# Access Compliance Report

## Public Rights-of-Way

### (Curb Ramps)

Intersection ID: 15001	Main Street: N_DOTGER_AV	Cross Street: VAIL_AV	Location:	W
ADA ID: B17ED310C2DA	Ramp Type: Perp	Initial Pass/Fail: Fail	Overall Compliance: No	Severity Score: 12.5

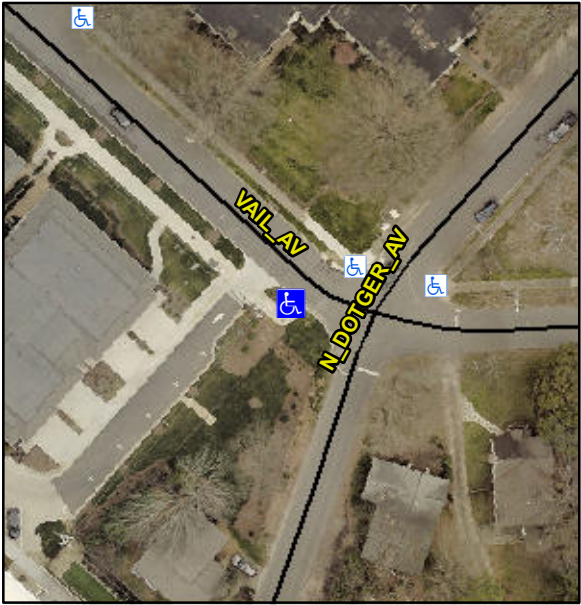
Codes/Mitigation Info/Possible Solution			Field Measurements/Component Compliance		
	Possible Solutions:		<b>Compliance</b>	<b>Description</b>	<b>Data</b>
	<b>Remove &amp; Replace Entire Ramp.</b>		<b>No</b>	Ramp Length (in)	<b>96.0</b>
			<b>Yes</b>	Ramp Width (in)	<b>68.0</b>
			<b>N/A</b>	Flare Type LT	<b>N/A</b>
			<b>N/A</b>	Flare Slope LT (%)	<b>N/A</b>
			<b>N/A</b>	Flare Traversable LT?	<b>N/A</b>
			<b>N/A</b>	Landing Length (in)	<b>N/A</b>
			<b>N/A</b>	Landing Width (in)	<b>N/A</b>
			<b>N/A</b>	Landing Slope (%)	<b>N/A</b>
			<b>N/A</b>	Landing X Slope (%)	<b>N/A</b>
<p>Surveyor Notes:</p> <p><b>N/A</b></p> <p>PROW/ADA:</p> <p><b>R304.2.2</b></p>			<b>N/A</b>	Flare Type RT	<b>N/A</b>
			<b>N/A</b>	Flare Slope RT (%)	<b>N/A</b>
			<b>N/A</b>	Flare Traversable RT?	<b>N/A</b>
			<b>N/A</b>	DWS Provided?	<b>N/A</b>
			<b>N/A</b>	DWS Contrast?	<b>N/A</b>
			<b>N/A</b>	DWS Length (in)	<b>N/A</b>
			<b>N/A</b>	DWS Full Width?	<b>N/A</b>

<b>N/A</b>	DWS Offset (in)	<b>N/A</b>
			<b>N/A</b>	Shared Landing?	<b>N/A</b>
			<b>N/A</b>	Gutter Ponding?	<b>N/A</b>
			<b>N/A</b>	Gutter Lip Ht (in)	<b>N/A</b>
			<b>N/A</b>	Painted X Walk1?	<b>No</b>
				X Walk 1 Direction	<b>To NE</b>
			<b>N/A</b>	X Walk 1 Width (in)	<b>N/A</b>
				X Walk 1 Slope (%)	<b>0.5</b>
				X Walk 1 X Slope (%)	<b>3.0</b>
			<b>N/A</b>	Ramp inside XWalk1?	<b>N/A</b>
			<b>N/A</b>	Road Slope (%)	<b>N/A</b>
			<b>N/A</b>	Road X Slope (%)	<b>N/A</b>
			<b>N/A</b>	Any Obstructions?	<b>N/A</b>
				Obstruction Type	
			<b>N/A</b>		
			<b>N/A</b>		
			<b>N/A</b>		
			<b>N/A</b>		
			<b>N/A</b>		
			<b>N/A</b>		
			<b>N/A</b>		
			<b>N/A</b>		
			<b>N/A</b>		
Total Cost:		<b>\$ 1850.00</b>			
			<b>N/A</b>		
			<b>Yes</b>	Surface Condition? (G/P)	<b>Good</b>
